1017 SOLAR ACCESS FOR LAND DIVISIONS AND REPLATS

CLACKAMAS COUNTY ZONING AND DEVELOPMENT ORDINANCE

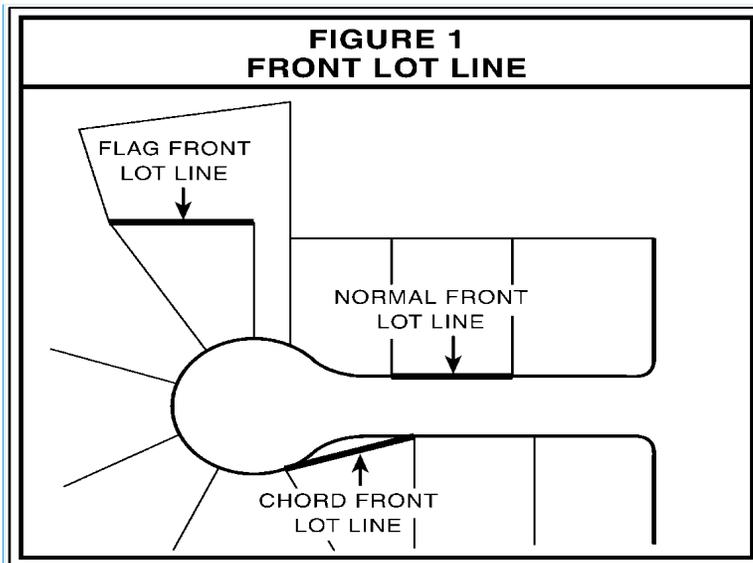
Commented [DH1]: Change to Figure 1017-1

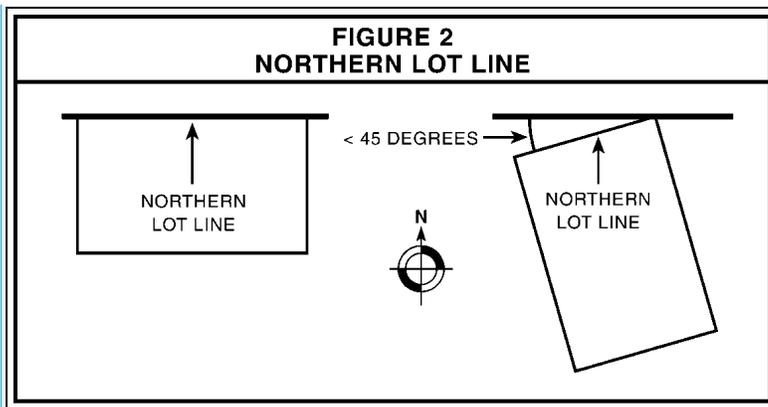
Commented [DH2]: Change to Figure 1017-2

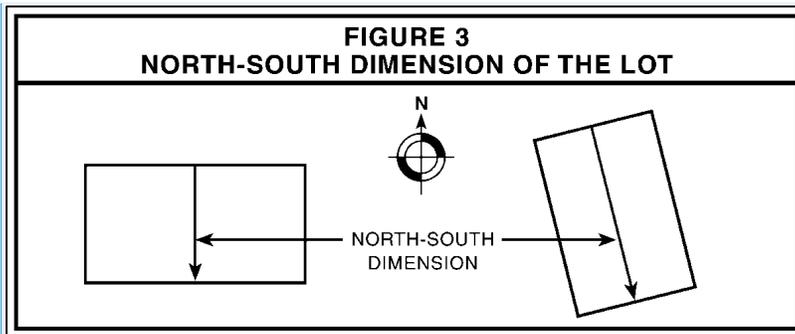
Commented [DH3]: Change to Figure 1017-3 and delete "of the lot" from the title

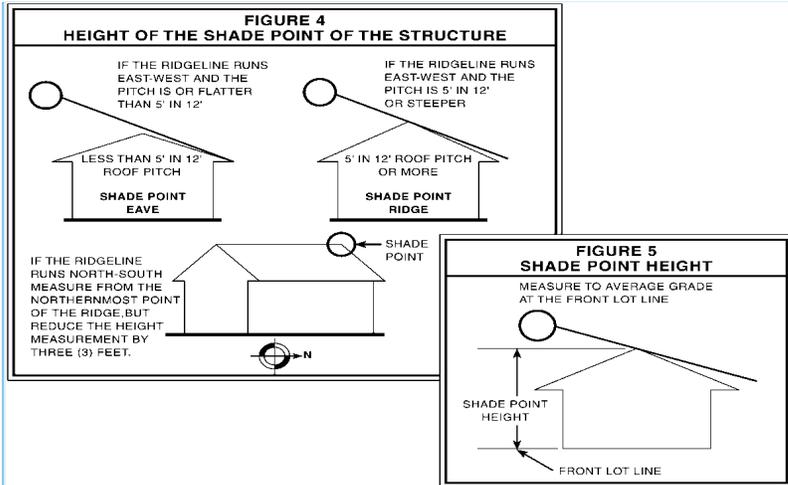
Commented [DH4]: Repeal Figures 4 and 5

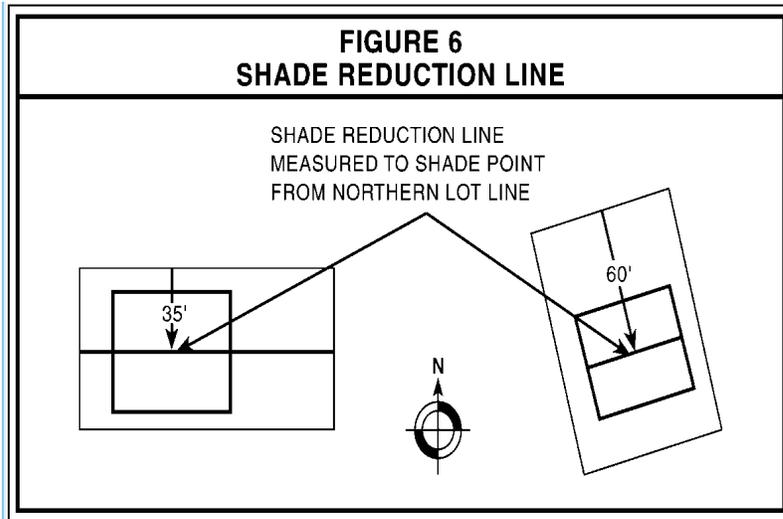
Commented [DH5]: Repeal Figure 6

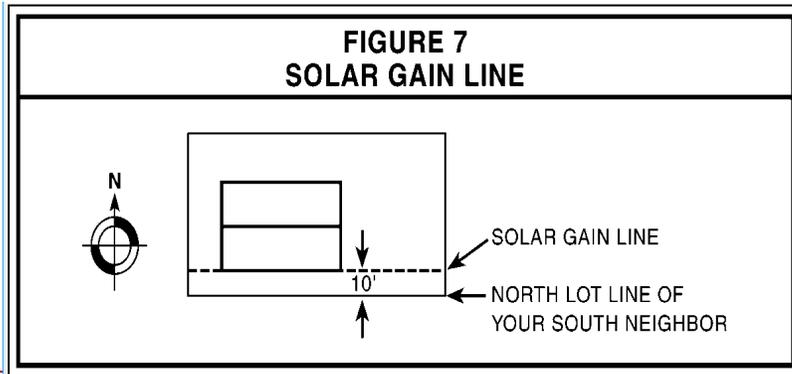
Commented [DH6]: Repeal Figure 7

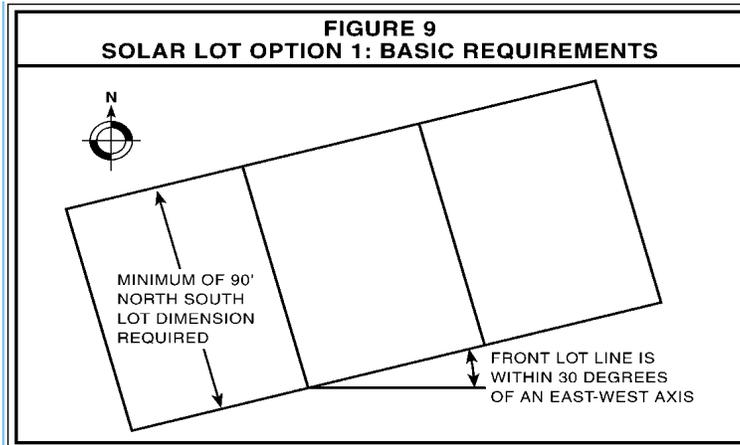
Commented [DH7]: Change to Figure 1017-4, change the title to Solar Access Design Standard, and change north south lot dimension to north-south dimension

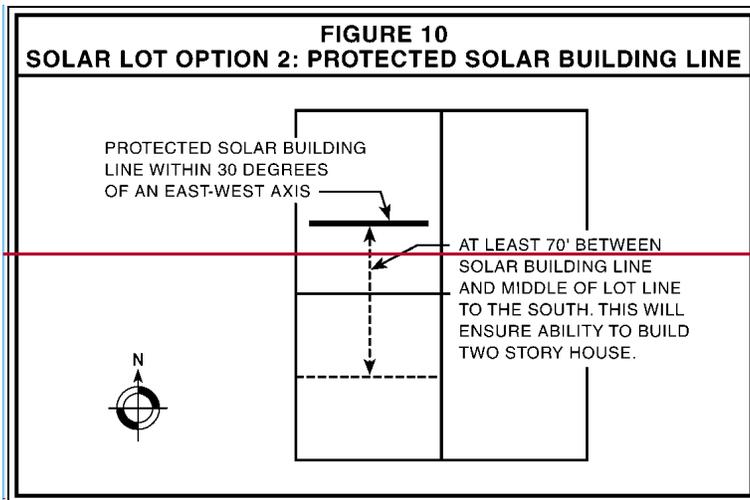
Commented [DH8]: Repeal Figure 10

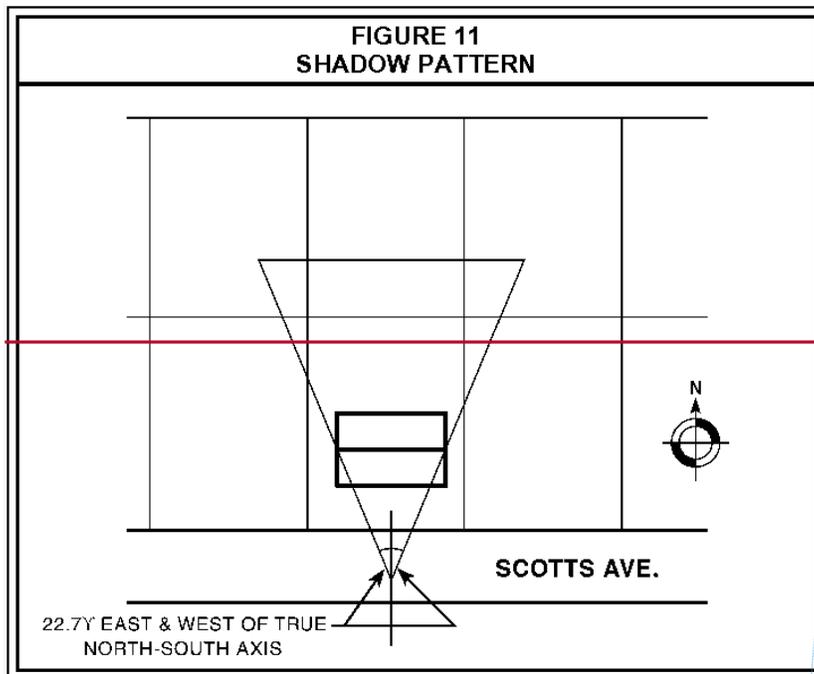
Commented [DH9]: Repeal Figure 11
